REVISION "C"

△ ADDENDUM NO. 3 NEW SHEET 12/19/2000

4 REDLINE NO. 4 REPLACEMENT SHEET 9/07/2001

MARYLAND DOT - STATE HIGHWAY ADMINISTRATION
Office of Traffic & Safety
TRAFFIC ENGINEERING DESIGN DIVISION
GENERAL INFORMATION SHEET
PHASE 2 CONSTRUCTION
MD 28 (DARNESTOWN RD) AND MUDDY BRANCH ROAD

PHASE 2 WIRING DIAGRAM

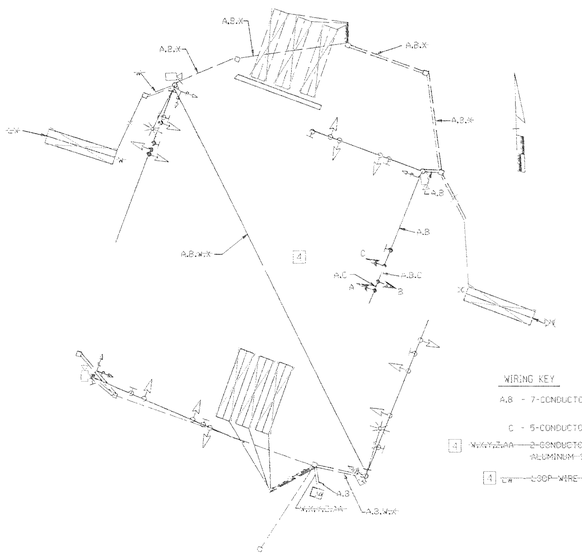
QUANTITY	UNIT	SPECIFICATION SECTION	DESCRIPTION
11	SF	813	INSTALL OVERHEAD SIGN
~~4 120~~	~~LF~~	~~805~~	~~FURNISH AND INSTALL 1 INCH ELECTRICAL CONDUIT - GALVANIZED SLEEVE~~
~~4 800~~	~~LF~~	~~810~~	~~FURNISH AND INSTALL ELECTRICAL CABLE - 2 CONDUCTOR (ALUMINUM SHIELDED)~~
15	LF	810	FURNISH AND INSTALL ELECTRICAL CABLE - 5 CONDUCTOR (NO 14 AWG)
1100	LF	810	FURNISH AND INSTALL ELECTRICAL CABLE - 7 CONDUCTOR (NO 14 AWG)
100	LF	556	FURNISH AND INSTALL 24 INCH WHITE REMOVABLE PREFORMED PAVEMENT MARKING TAPE
3	EA	814	RELOCATE EXISTING SIGNAL HEADS
13	EA	814	FURNISH AND INSTALL 12 INCH VEHICULAR TRAFFIC SIGNAL HEAD
~~4 2950~~	~~LF~~	~~810~~	~~FURNISH AND INSTALL LOOP WIRE ENCASED IN FLEXIBLE TUBING (NO 14 AWG)~~
~~4 620~~	~~LF~~	~~815~~	~~FURNISH AND INSTALL SAWCUT FOR SIGNAL (LOOP DETECTOR)~~
1	LS	SP	REMOVE AND DISPOSE OF EXISTING EQUIPMENT
4	EA	SP	COVER SIGNAL HEAD/ SIGN
~~4 5~~	~~LF~~	~~805~~	~~FURNISH AND INSTALL 1 INCH LIQUID TIGHT FLEXIBLE NON-METALLIC CONDUIT FOR DETECTOR SLEEVE~~

~~4 W,W,Y,Z,AA — 2-CONDUCTOR ELECTRICAL CABLE (NO.14 AWG) ALUMINUM SHIELDED~~

~~4 CW — LOOP WIRE (NO.14 AWG)~~
